THE CITY OF MENASHA PARKS AND RECREATION BOARD AND PLAN COMMISSION

Tuesday, February 14, 2017 4:30 PM

Jefferson Park Vision Plan February 2, 2017 Steering Committee Notes

Jefferson Park - Concept 1

The Menasha Veranda

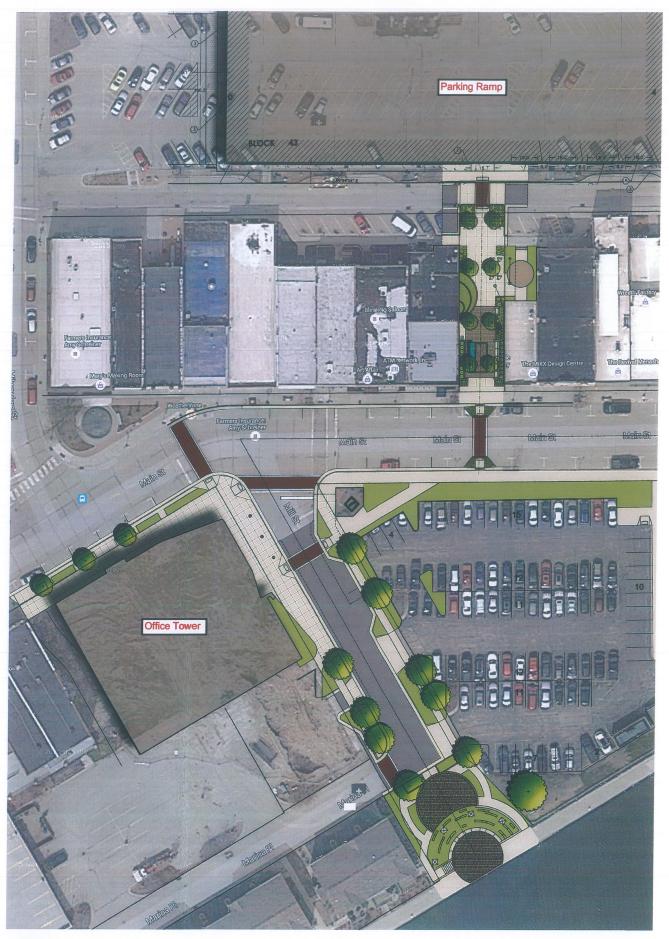
At this time, staff is soliciting input of the Parks Board and recommendation of the Plan Commission on the Mill Street terminus conceptual plan including the columns use.

Staff recommends Plan Commission approval of the Mill Street terminus conceptual design including the reuse of the four former First National Bank building columns, as proposed.
